SUBMITTAL OF HANFORD FACILITY RESOURCE CONSERVATION AND RECOVERY ACT (RCRA) PERMIT MODIFICATION NOTIFICATION FORM 24590-HLW-PCN-ENV-06-015

Hanford Facility RCRA Permit Modification Notification
Form 24590-HLW-PCN-ENV-06-015

24590-HLW-PCN-ENV-06-015

The purpose of this Class 1 prime modification is to update the Piping and Instrumentation Diagrams (P&IDs) for the HLW Radioactive Liquid Waste Disposal System (RLD) in Appendix 10.2 of the Dangerous Waste Permit. The following source P&IDs are submitted to replace the permit P&IDs currently in Appendix 10.2.

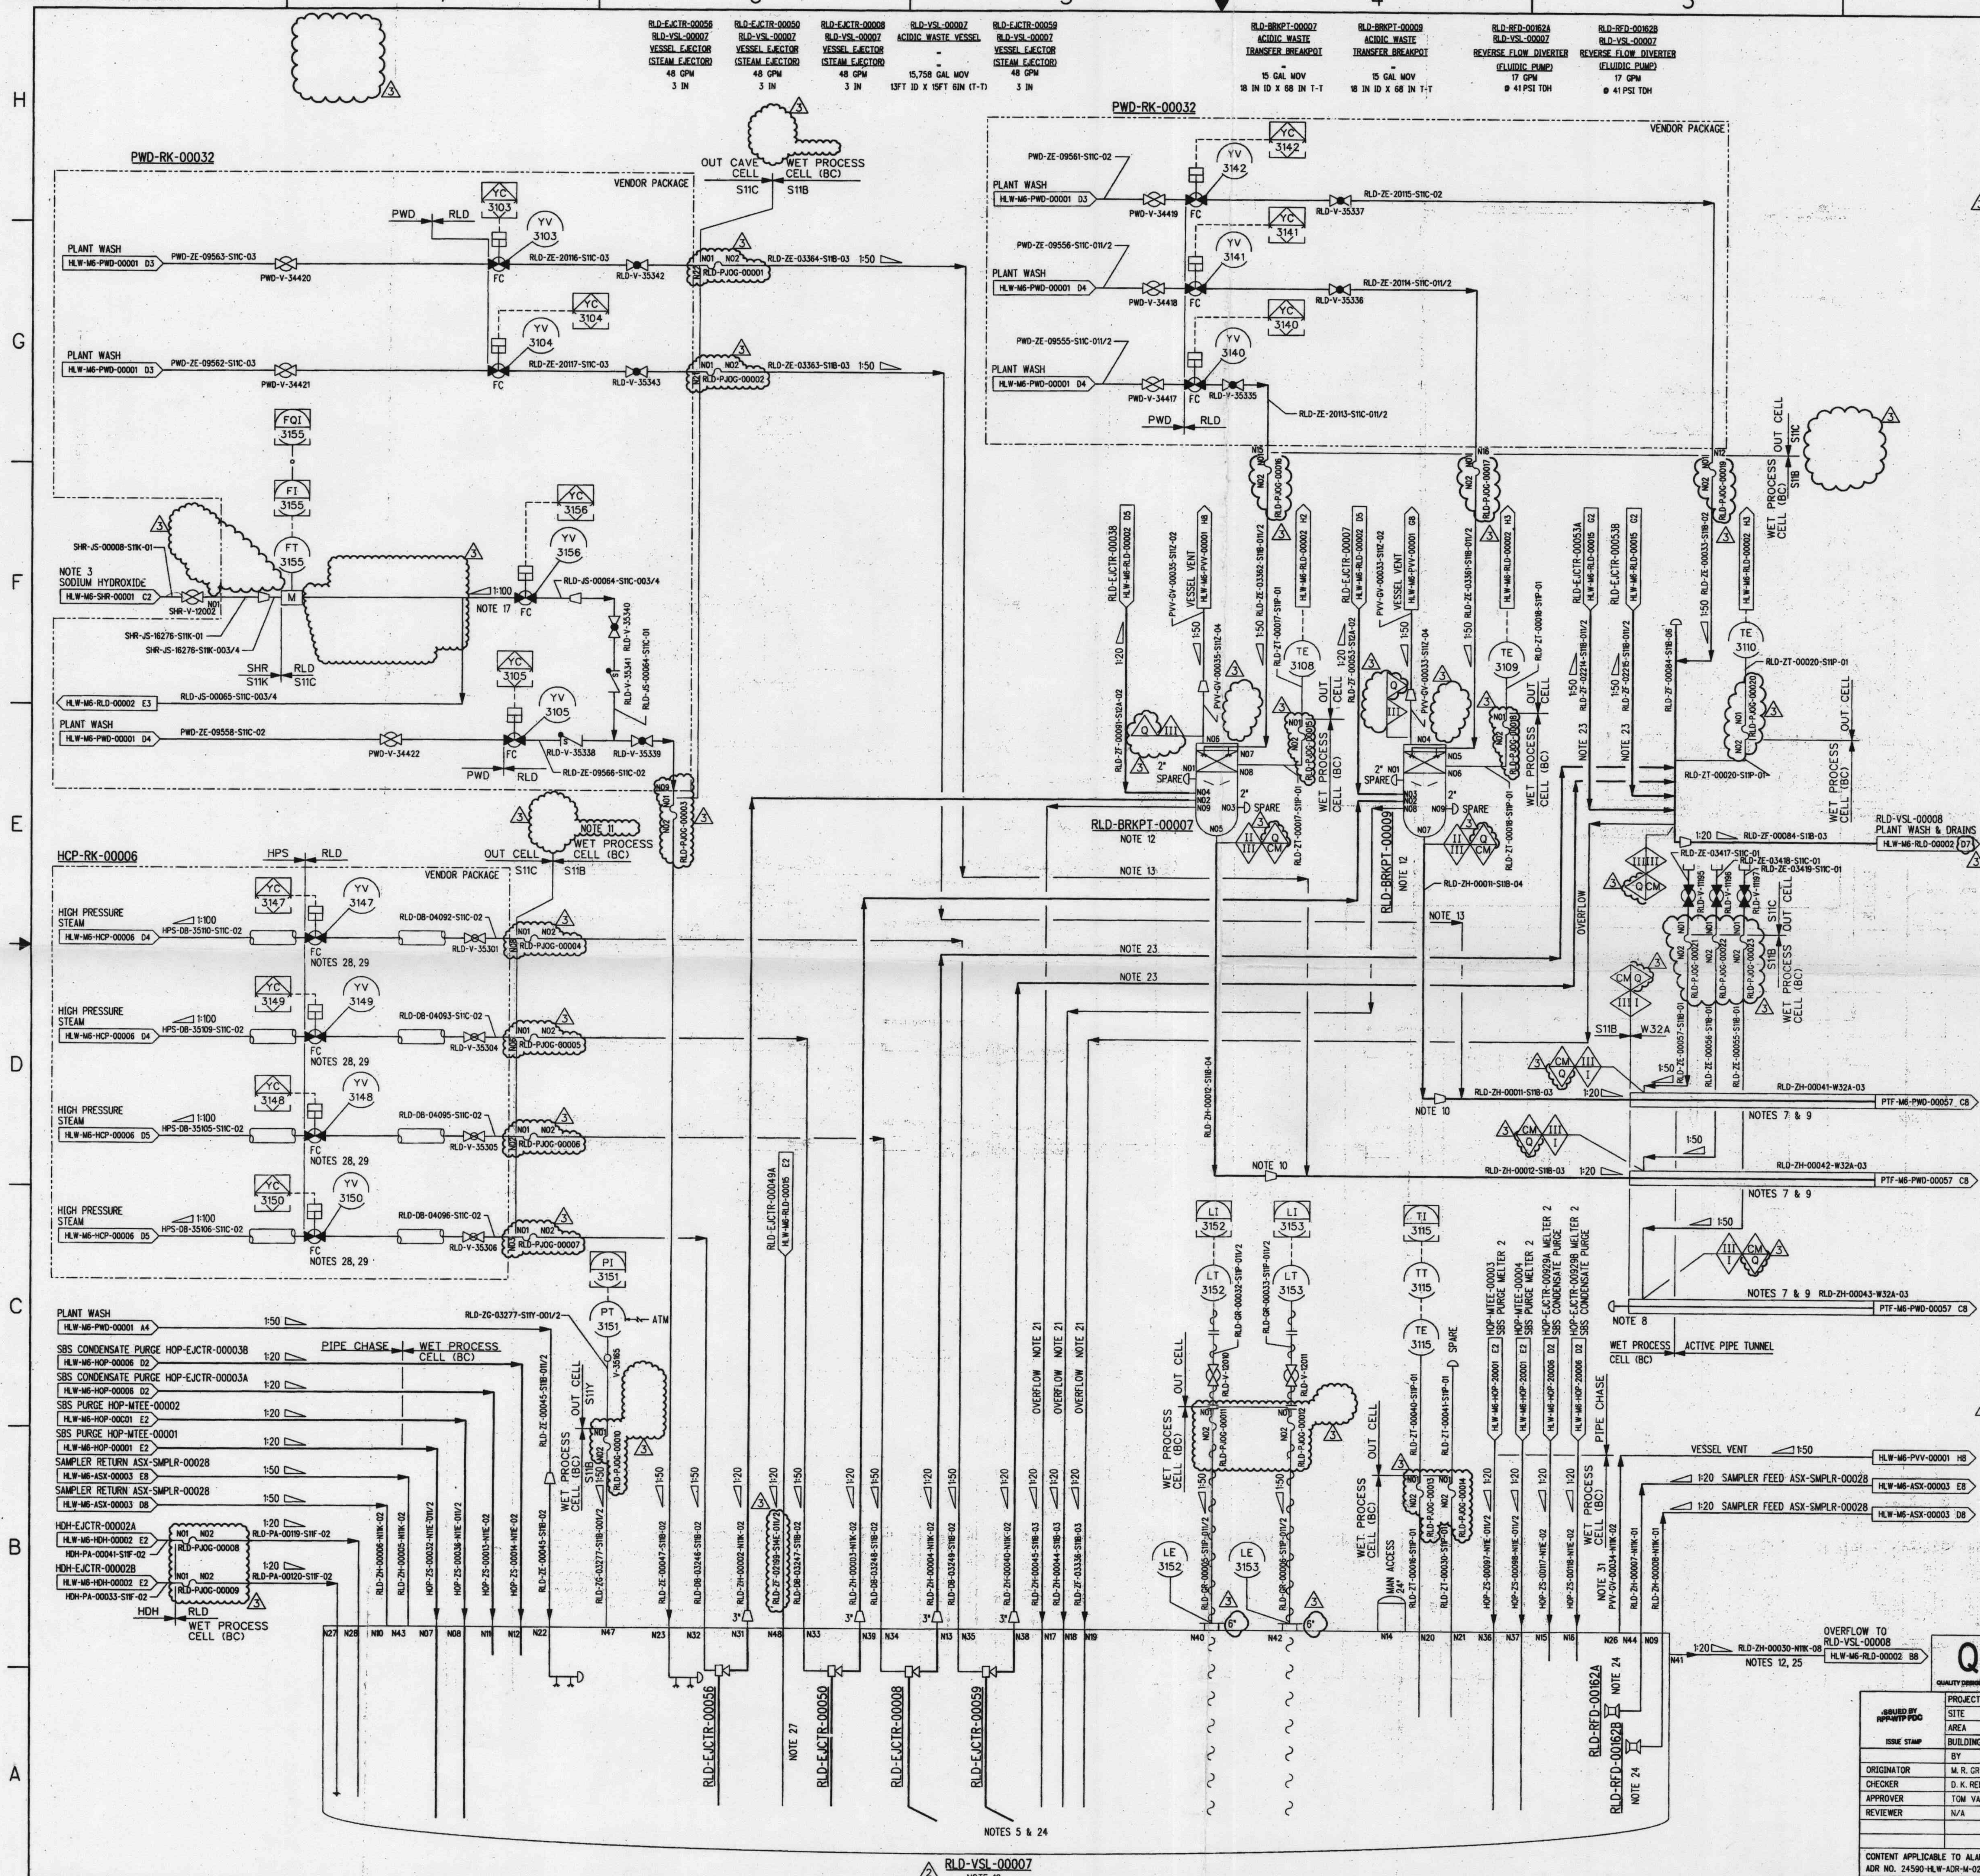
- Reconfigured vessel nozzles
- Deleted one spare vessel level instrument
- Modified pipe specification from N11F to N11K and from S11B to S14E

33. REVISED TO INCORPORATE P-JOGGLES. DELETED BACKFLOW PREVENTER. REVISED QUALITY CLASS DESIGNATIONS. DELETED FE-3155. ADDED/DELETED/REVISED NOTES AND REFERENCES.

P&ID - HLW
RADIOACTIVE LIQUID WASTE DISPOSAL SYSTEM
PLANT WASH & DRAINS VESSEL

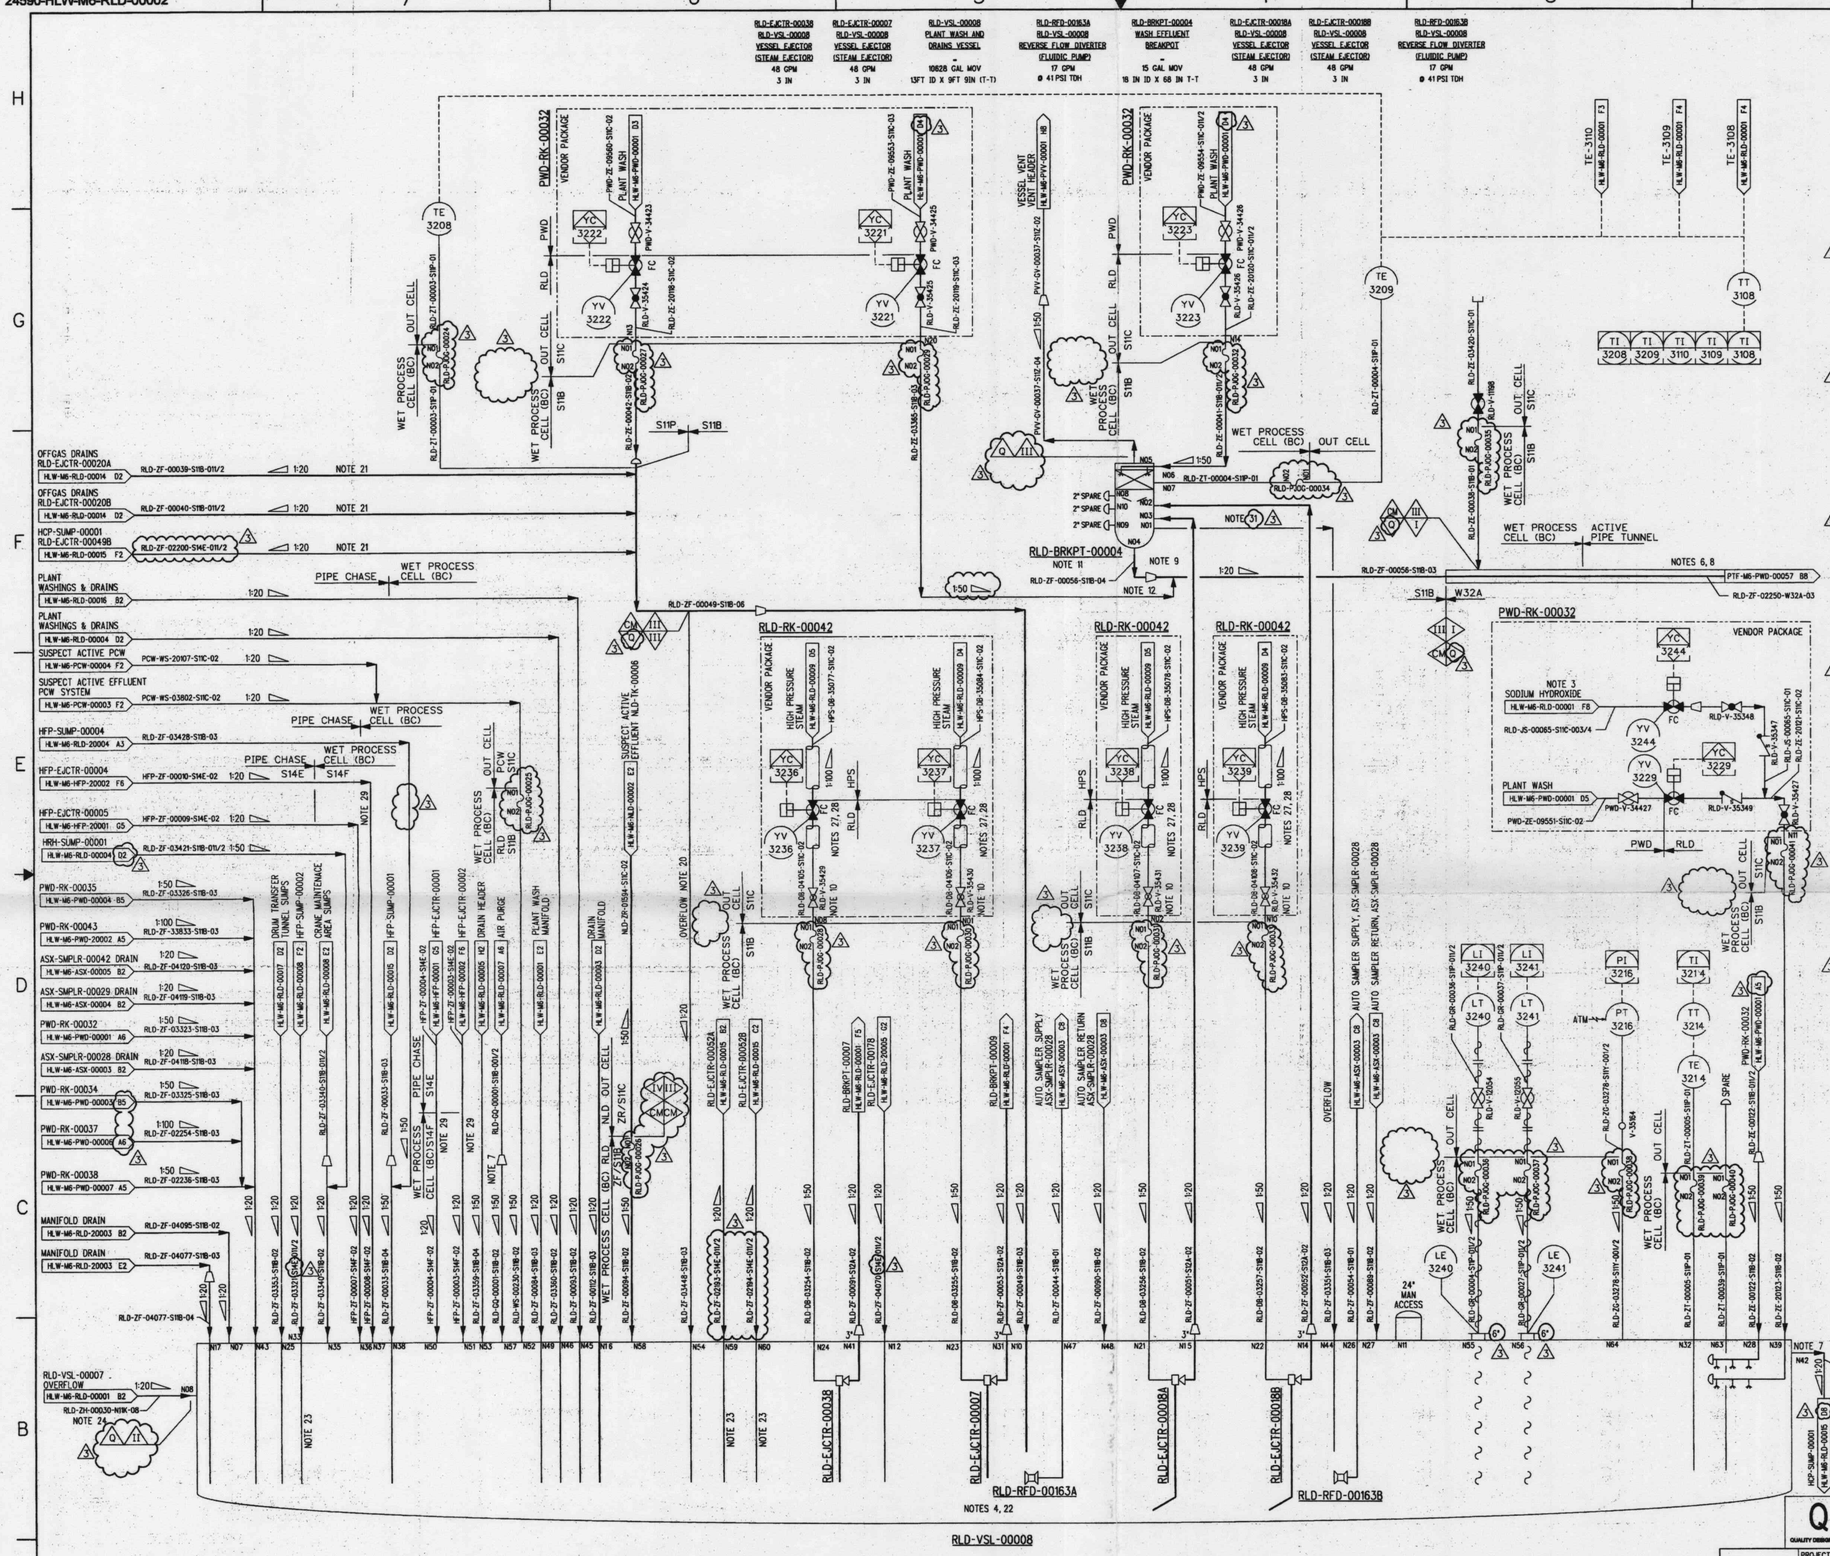
24590-HLW-M6-RLD-00002 HLW Radioactive Liquid Waste Disposal System Plant Wash and Drains Vessel (see Revision Note 33)

- Deleted one spare vessel level instrument
- Modified pipe specification from S11B to S14E and from S12A to S14E/S14F

33. REVISED TO INCORPORATE P-JOGGLES. REVISED QUALITY LEVEL DESIGNATIONS. REVISED PIPE SPEC. FROM S1B TO S14E. REVISED/ADDED/DELETED NOTES.

24590-HLW-M6-RLD-20003

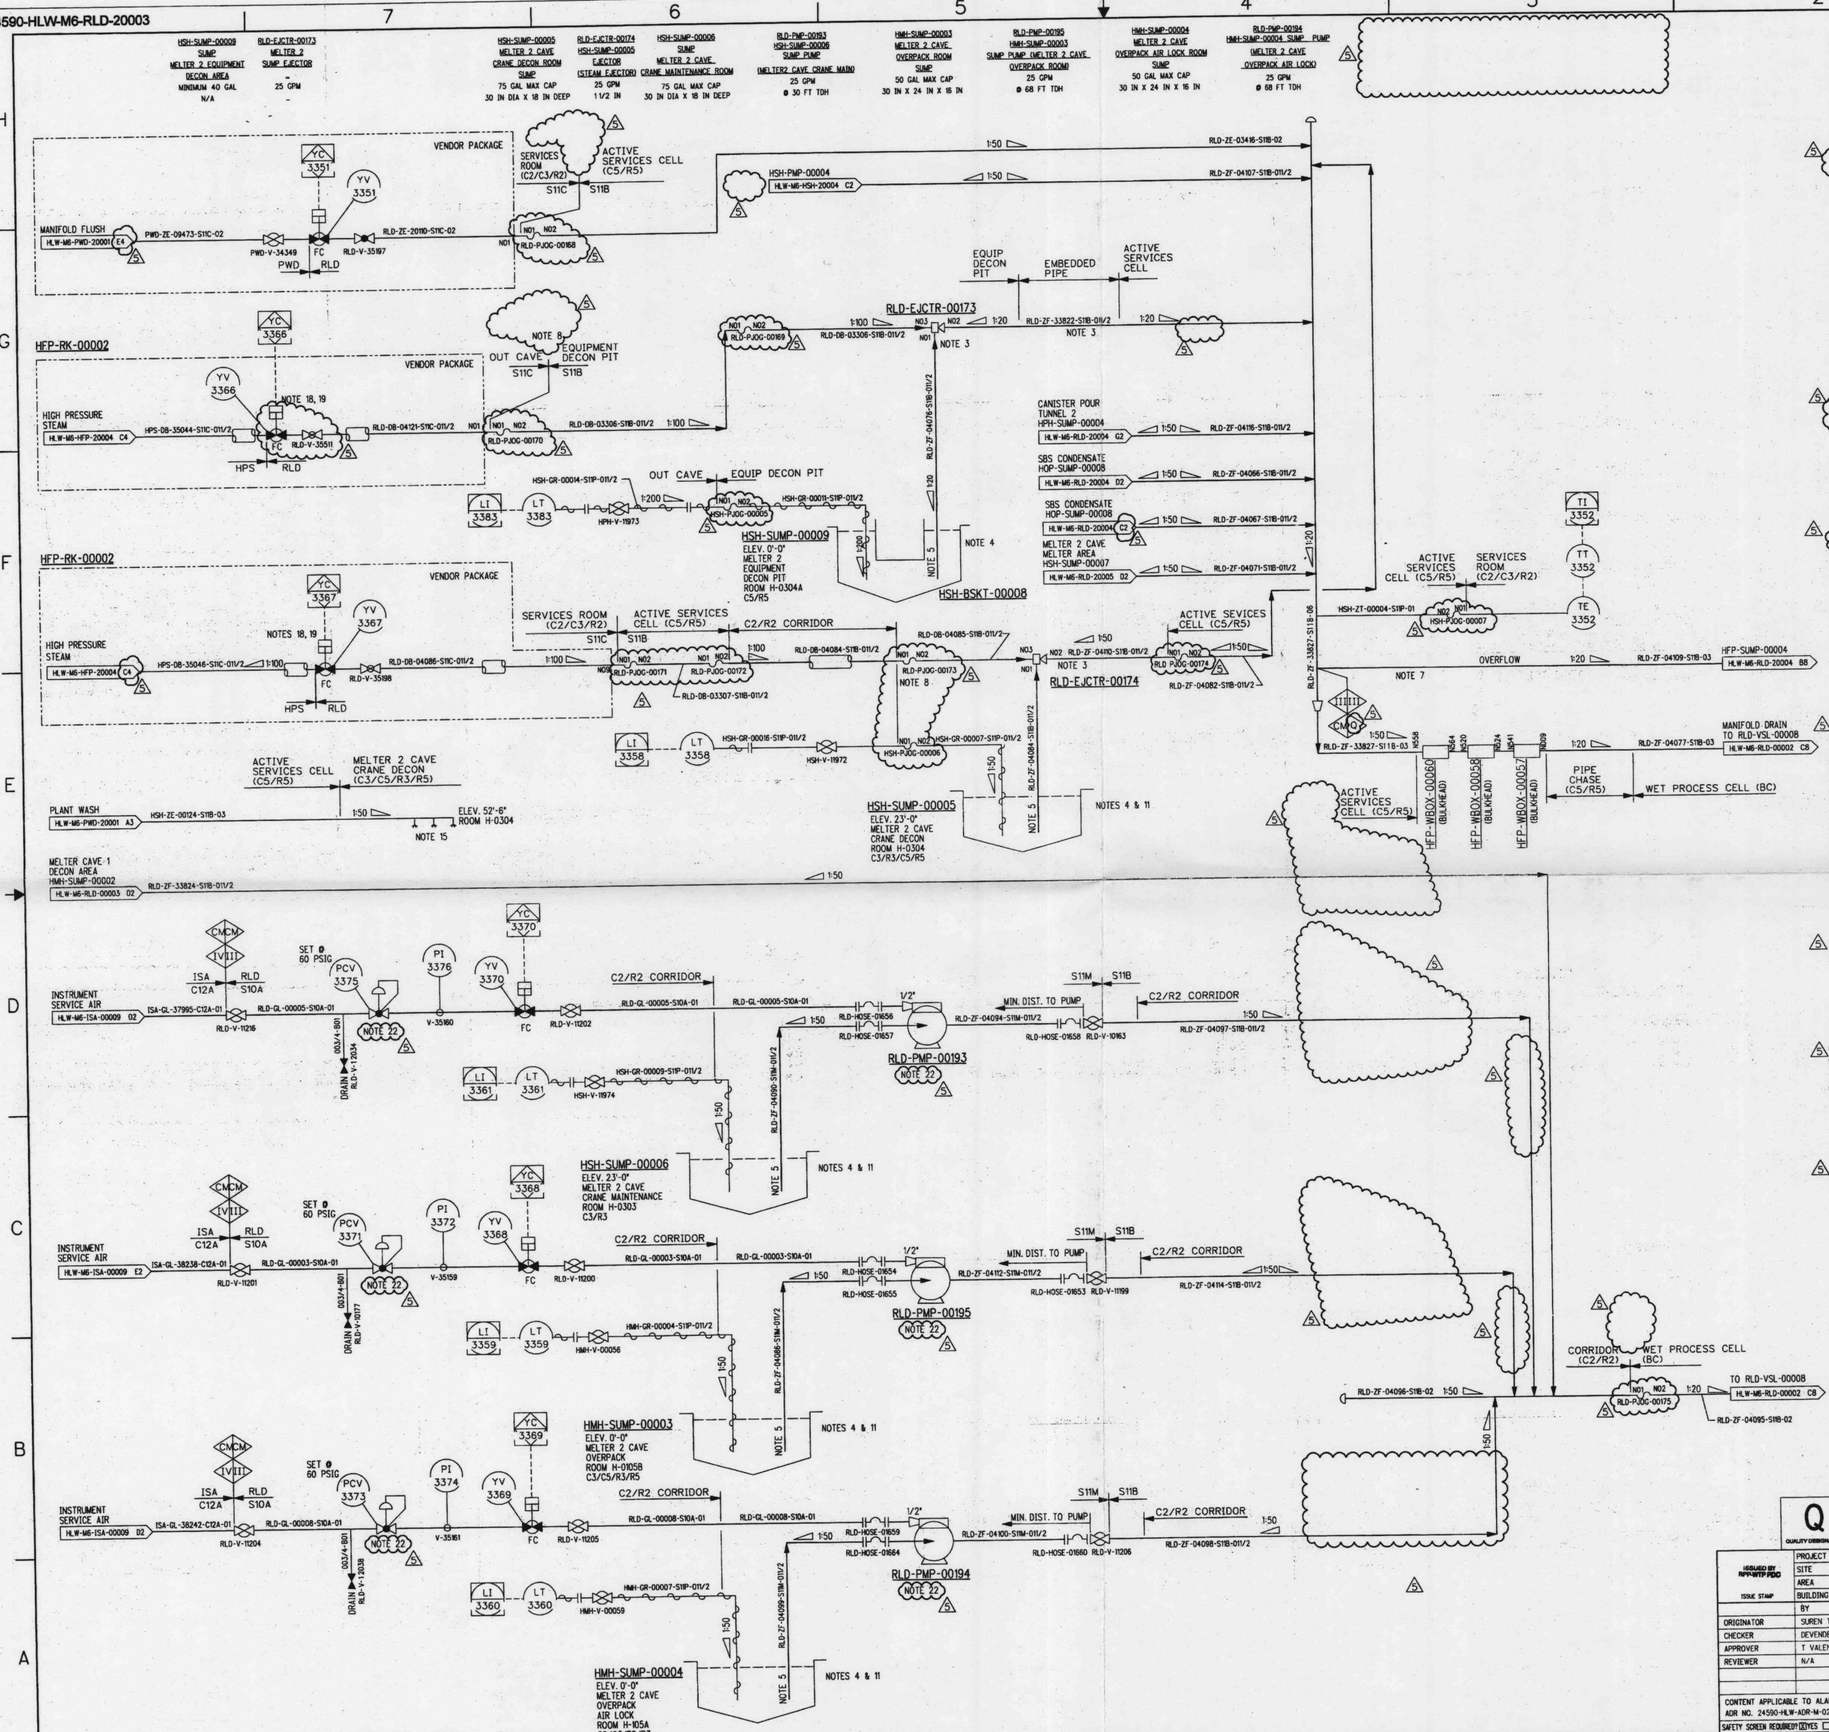
22. FILTER REGULATOR IS TO BE SUPPLIED WITH THE DIAPHRAGM PUMP
23. REVISED TO INCORPORATE P-JOGGLES. REVISED QUALITY/SEISMIC FLAGS. REMOVED BACKFLOW PREVENTERS ON PUMP DISCHARGE LINES. ADDED/DELETED/REVISED NOTES, HOLDS, AND REFERENCES. CHANGED RLD-V-35511 TO PLUG VALVE, CHANGED YV-3366 TO BALL VALVE AND ADDED FC FOR FAIL POSITION. REVISED/DELETED LINE NUMBERS.
